PLANNING ACT 2008

RELEVANT REPRESENTATION

AQUIND INTERCONNECTOR

MMO REF: DCO/2018/00016

Figure 1. Benthic baseline PSA results based on Folk Classification. No grabs returned from sampling stations 8 and 22. (taken from Figure 9, Benthic Ecology Survey Report)

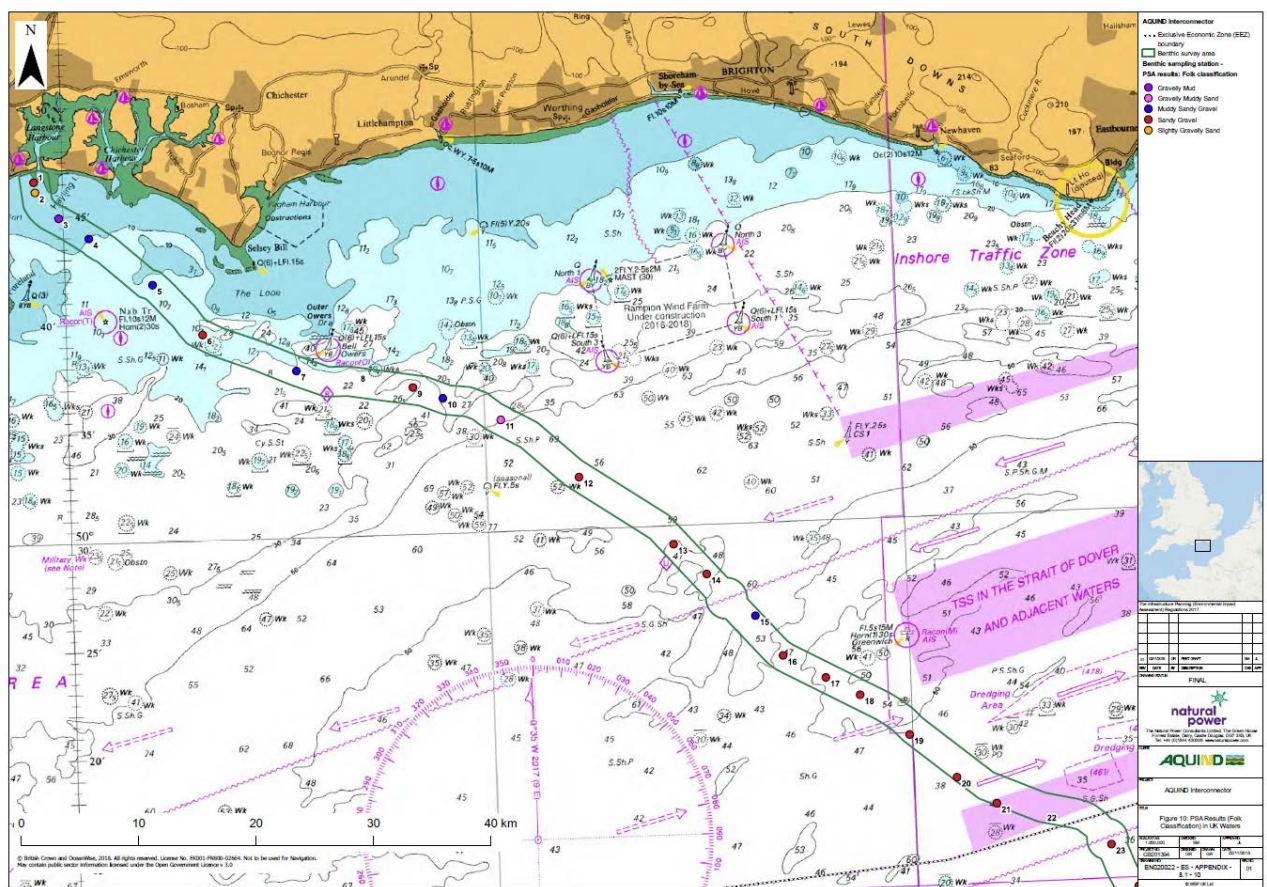
- 8.14. In the nearshore section of the cable corridor, grab samples show a mixture of sandy gravel, gravelly mud and slightly gravelly sand, but are predominantly muddy sandy gravel. This indicates that material from the nearshore section is less consistently coarse than the offshore section. Table 1 (below) details the coordinates of the sampling locations of the sediment contaminant analysis; in order to compare how they represent the nearer shore section of the cable corridor.

8.15. It is apparent from this table that there is some likely overlap between the benthic survey locations and the sediment contaminant locations. However, it is not clear which benthic survey stations were tested for sediment contaminant analysis. The MMO Results template submitted by the applicant lists sample names by a number, though it is unclear whether these relate to the benthic survey samples as the references of the benthic sample locations are alphanumeric i.e. VC001. The applicant should clarify which benthic survey locations were tested for contaminant analysis. Once this has been clarified, we are able to determine the ‘cutting point’ of where contaminant analysis stops, and exemption due to particle size begins.
